December 31, 1982
ST-HL-AE-919
File No: G9.15

South Texas Project
Units 1 & 2
Docket Nos. STN 50-498, STN 50-499
Responses to NRC Review Questions

RESPONSES TO NRC QUESTIONS
220.06, 220.08, 220.09,
230.01, 230.04, 231.02 and 231.03

Figure 1

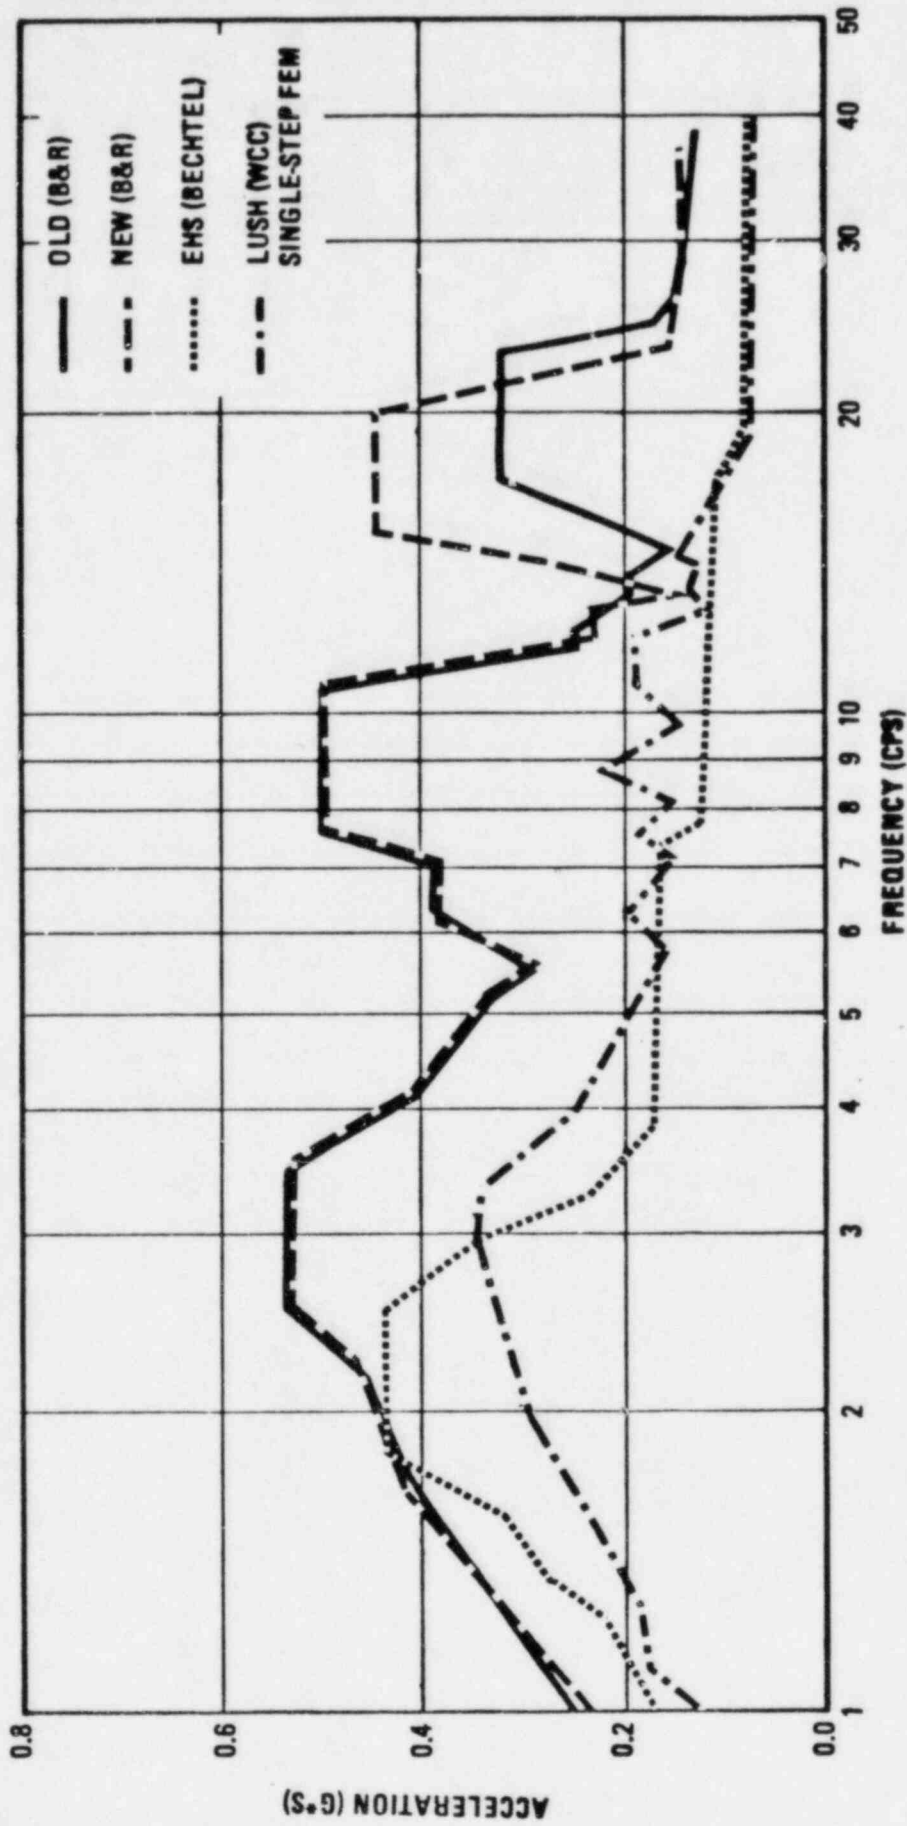
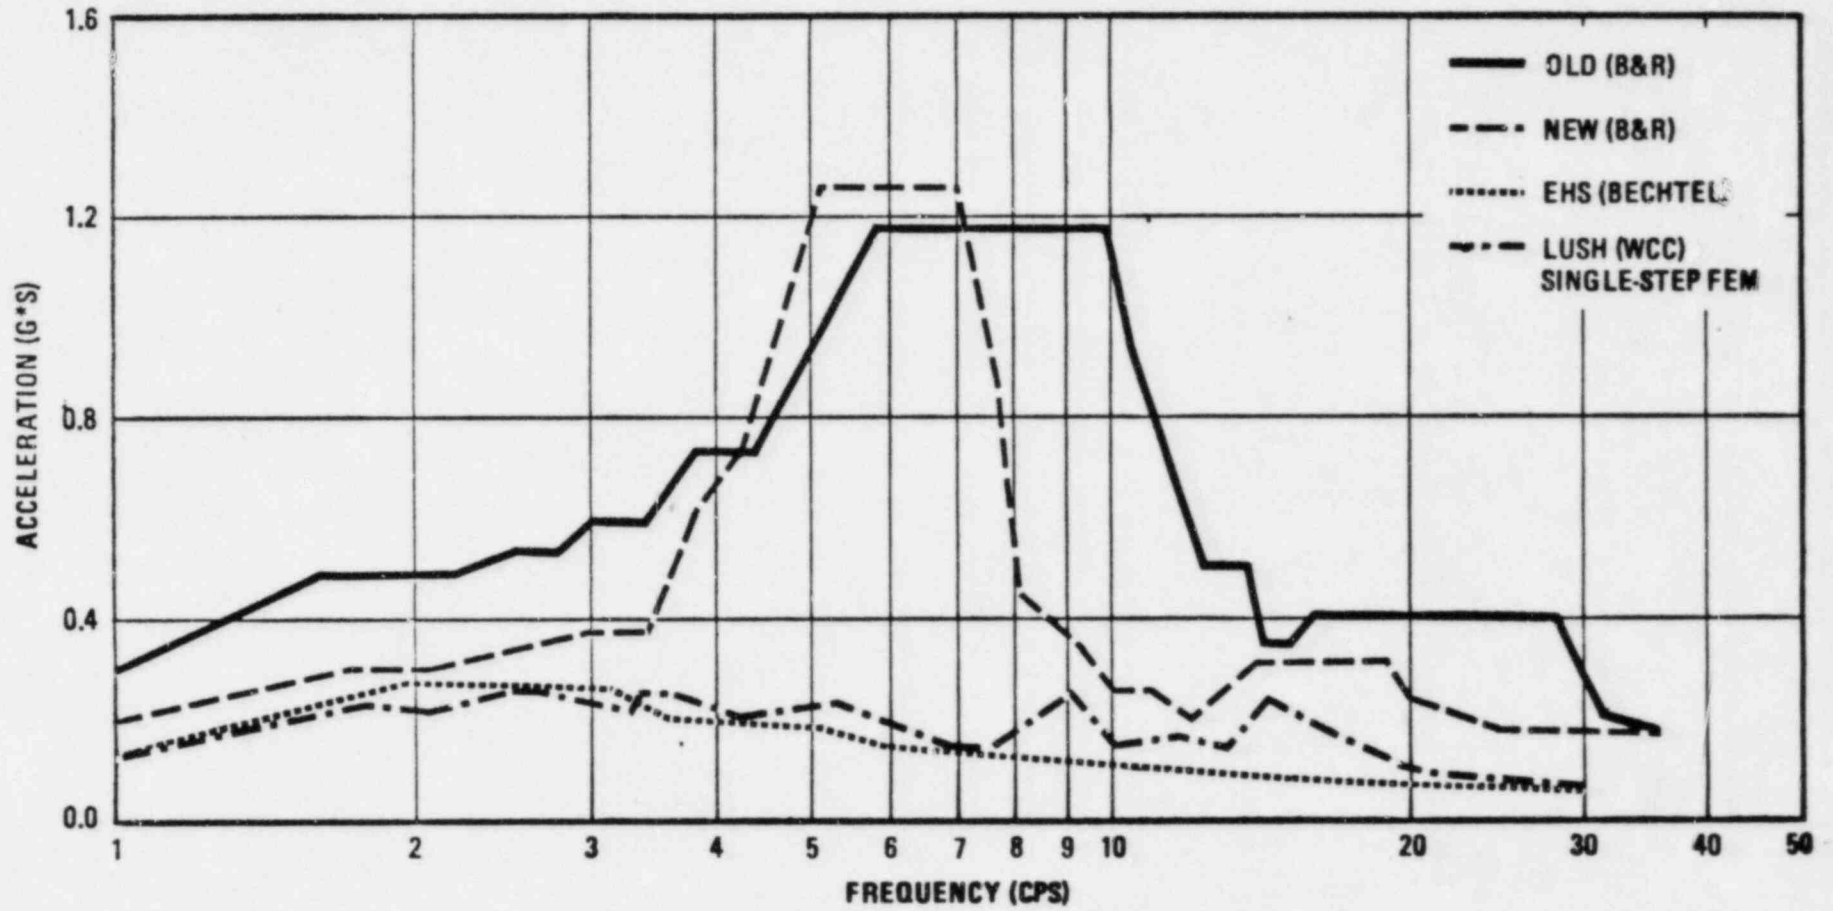
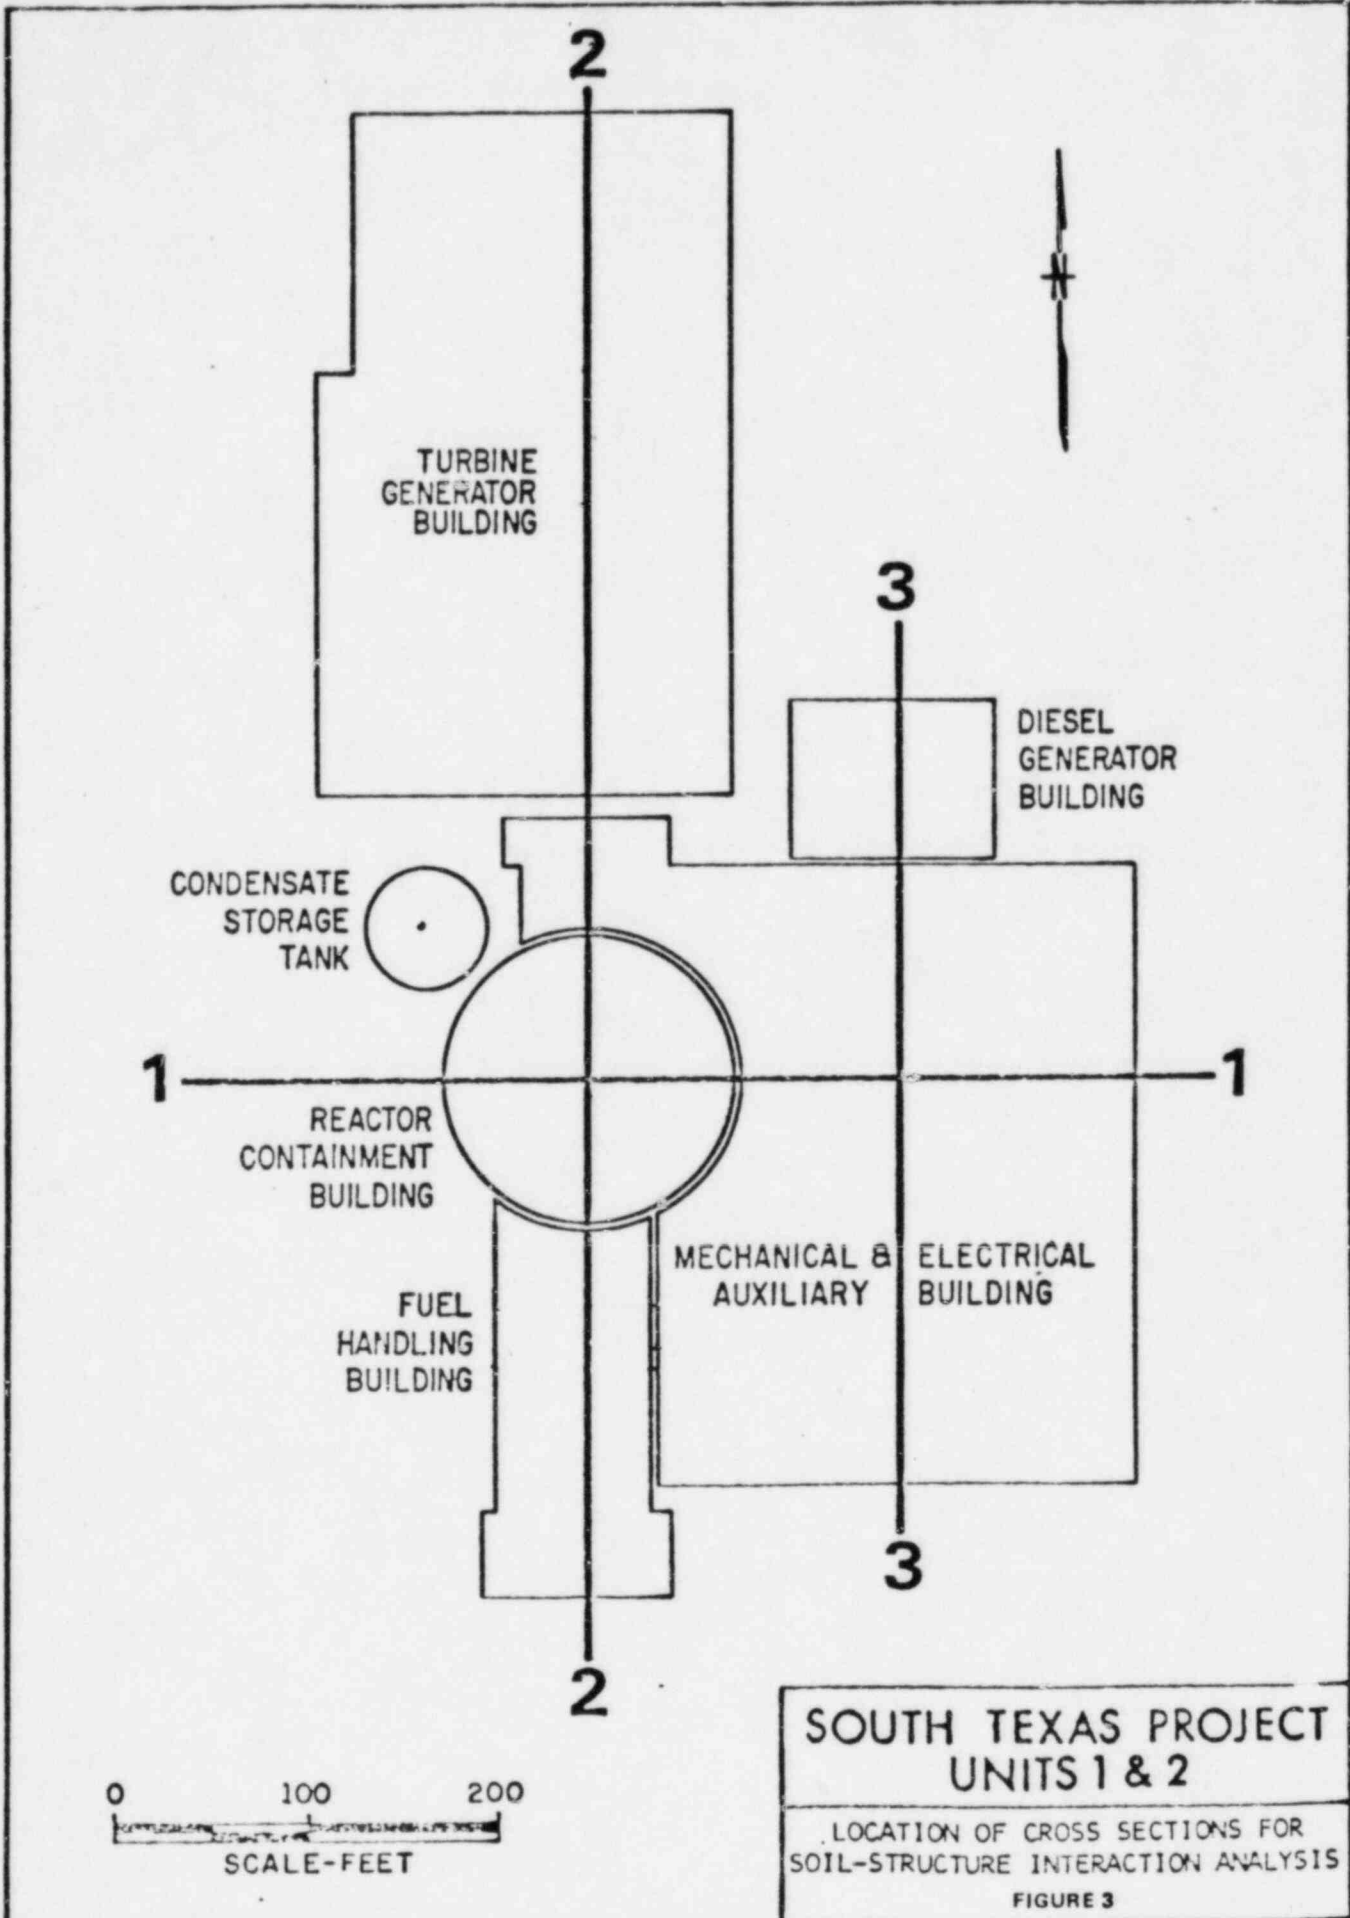
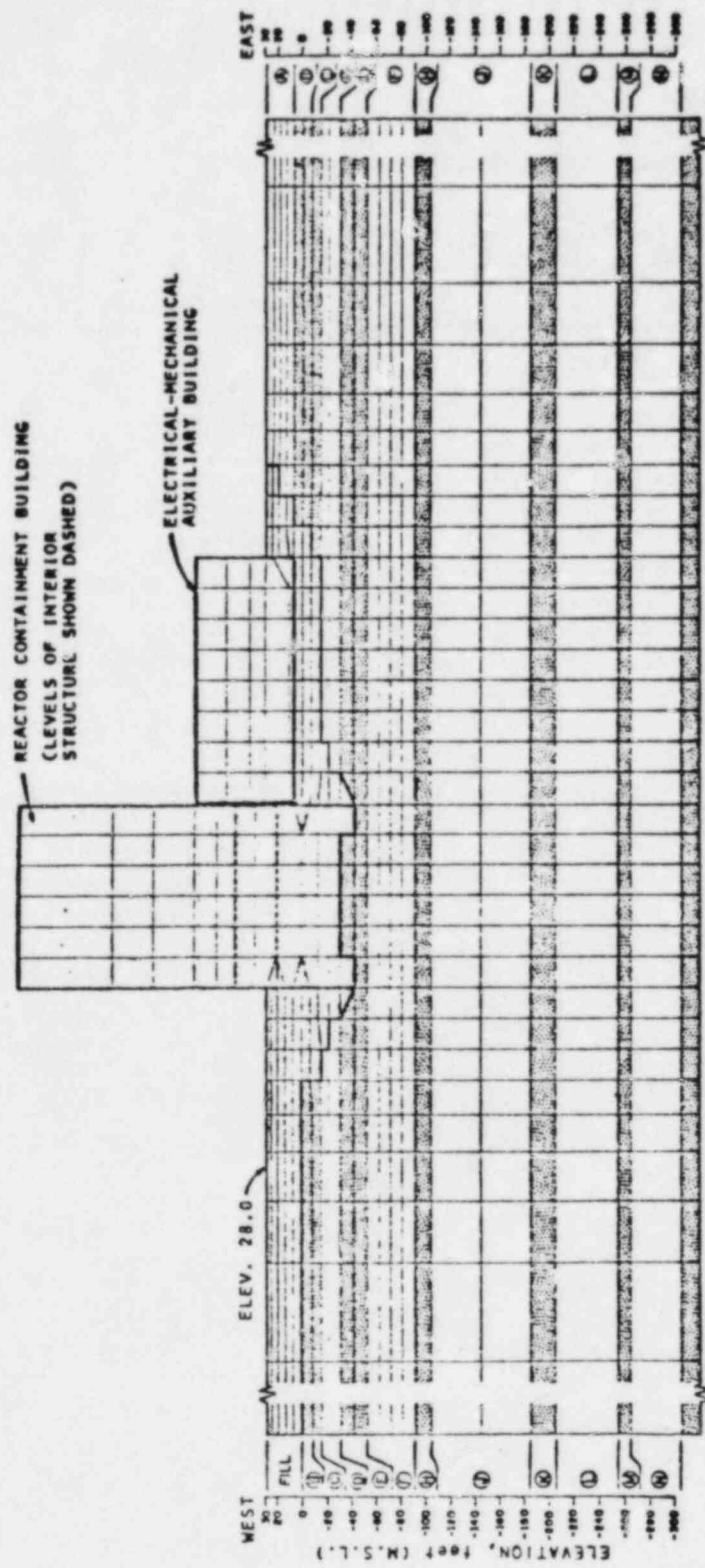
5. Clarification on the methodology and input used for the single-step FEM calculation of response spectra. It is emphasized that this calculation was introduced only to appropriately augment the EHS solution and demonstrate the over-conservatism of the two-step FEM spectral response in the high structural frequency range.

The Bechtel review of SSI analyses also addressed (1) the over-conservatism of the spectral response in the high frequency range as derived from the two-step FEM solution, and (2) the surmised sensitivity of the two-step FEM response spectra calculation to the structural configuration. These two concerns were addressed by incorporating single-step FEM solutions in conjunction with the EHS solutions in order to achieve an appropriate datum for the comparison of response spectra solutions by two-step FEM. Typical results are shown in Figures 1 and 2. In these figures the solid and dashed curves are the B&R solutions for "old" and "new" configurations of the structures. Both of these solutions by two-step FEM are characteristically over-conservative with respect to the dotted and dot/dashed curves representing the datum by EHS and single-step FEM solutions, and also exhibit frequency shifts and amplitude variations attributed to changes in the structural configuration. The shifts and variations in spectral response, however, are analytically originated by an artificial sensitivity related to the decoupled fixed-base models used in the second step analyses. Therefore the artificial nature of the changes in spectral response, plus the over-conservatism of the two-step FEM solution render the changes as inconsequential, and the EHS/single-step FEM datum spectra is considered to be a more realistic and governing evaluation of the seismic response spectra.

It is emphasized that the single-step FEM solutions used in the Bechtel study were developmental calculations performed by WCC, and were incorporated in the study only to augment the EHS solution and demonstrate the conservatism of the two-step FEM solutions in the high frequency range. For the single-step FEM solutions, the finite element modelling of the soil, as well as the three planar directions and the input motion considered are identical to those used in the two-step FEM solutions; refer to Figures 3, 4, 5 and 6. The fundamental difference between the two FEM's is that the two-step solution relies on decoupled lumped parameter structural models excited by base interaction motion derived from the first step-analyses, whereas the single-step solution consists of single transient analyses through planar finite element models of the coupled structure and soil. In both analyses identical accelerograms are used to define the input motion at the base of the idealized soil model. The artificial accelerograms were developed as described in the FSAR Section 3.7.1.2, and are in full compliance with R. G. 1.60 pertaining to (1) the comparison of the calculated free-field spectra at grade with the STP design response spectrum, and (2) the comparison of calculated response spectra at foundation level with 60% of the design spectrum.
